**Roost – 401 S 5th Street**

Design Review Application – Work Session discussion items following 5/13/15 DR Hearing
5/27/15

Enclosures: Sheet 1: Facade Diagrams

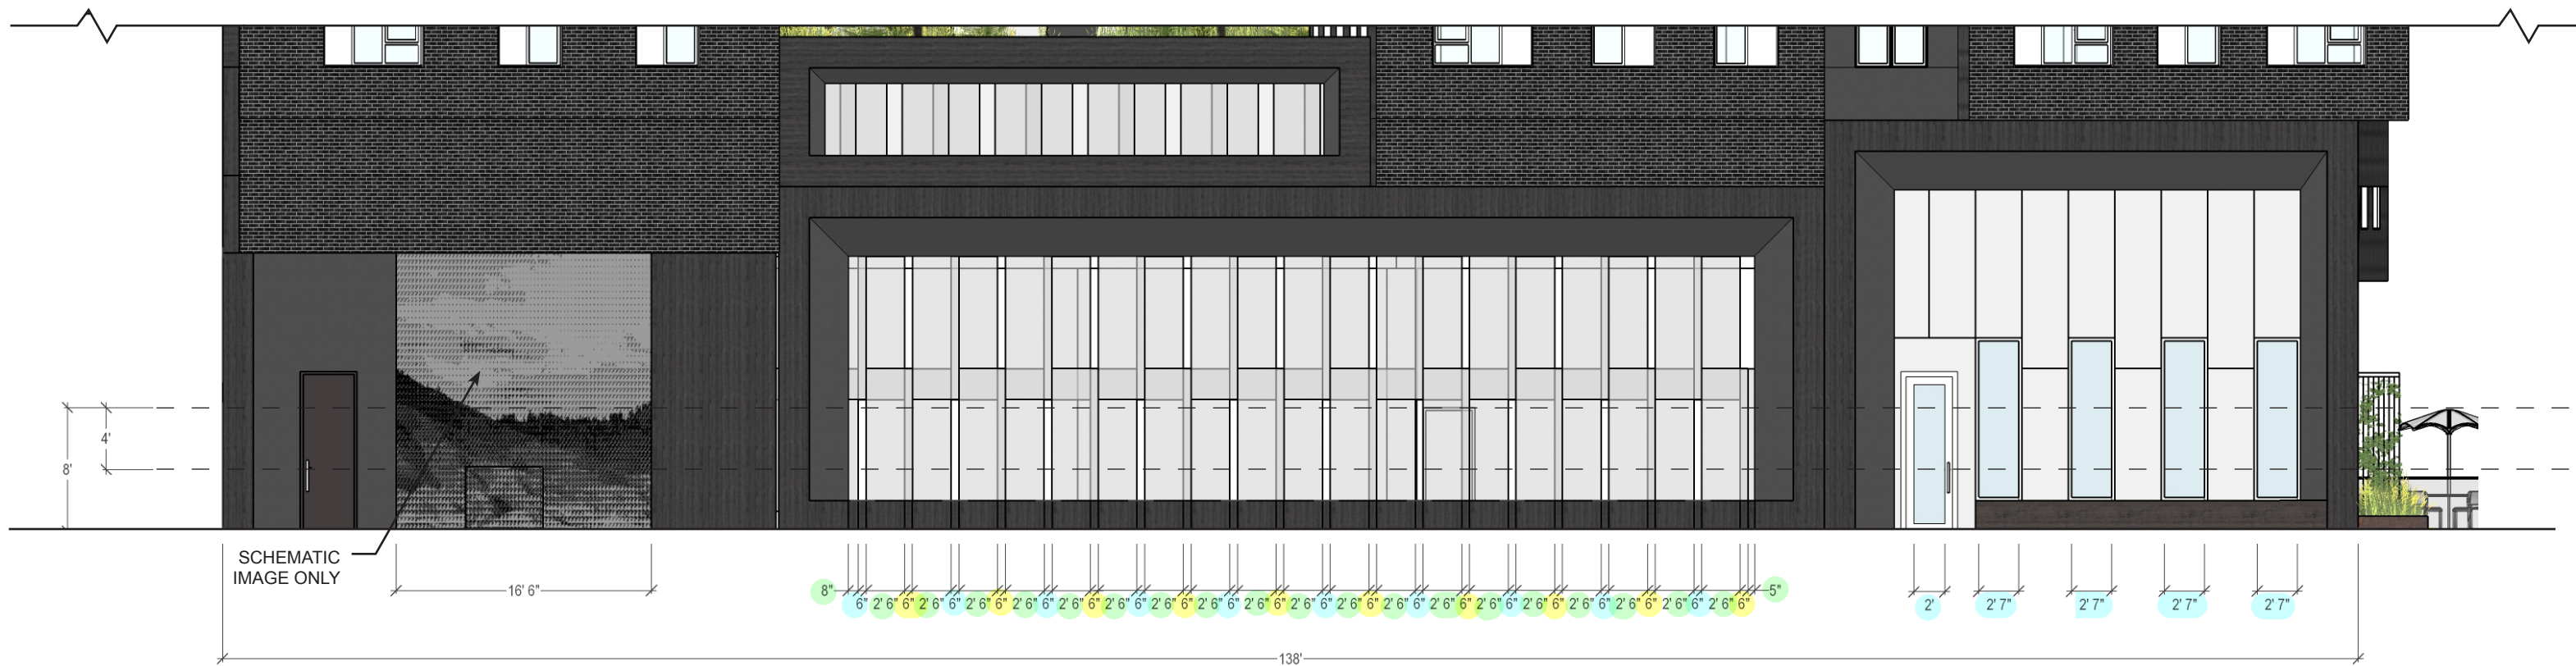
Site Specific Conditions of Approval***i. Provide a minimum of 12.5-percent façade transparency along the Myrtle Street first level frontage to meet the requirements of the departure process for the Downtown Design Standards and Guidelines.***

Please see the attached revised elevation showing the transparency levels along Myrtle. Following Staff's recommendation we have added glazing to the room at the corner of 5th and Myrtle, as well as further defining the transparency along the metal screen area. The metal screen is a layered design where we have a perforated mesh spaced to allow for openings into the naturally ventilated parking. In addition to the open areas of the façade, a portion of the metal mesh is 50% open/transparent which allows for the view of form and movement beyond the screen, without providing a direct view to the vehicles in the parking garage. We have included a few precedent images to convey the intent of this metal screen. While it is not clear glass, we believe it meets the intent of a transparent façade in this application.

The combined glazed area on the façade and the openings in the metal screen result in a 12.6% façade transparency (in the required 4'-8' range).

If the perforated metal mesh is added to this calculation it results in a façade transparency of 30.2%.

100% TRANSPARENCY =	69.3 SF	
50% TRANSPARENCY =	97.2 SF	
25% TRANSPARENCY =	5 SF	
TOTAL WALL AREA (4 TO 8 FT) =	552 SF	
TRANSPARENT AREA (100%) =	69.3 SF	(12.6% OF TOTAL WALL AREA)
TRANSPARENT AREA (>50%) =	166.5 SF	(30.2% OF TOTAL WALL AREA)
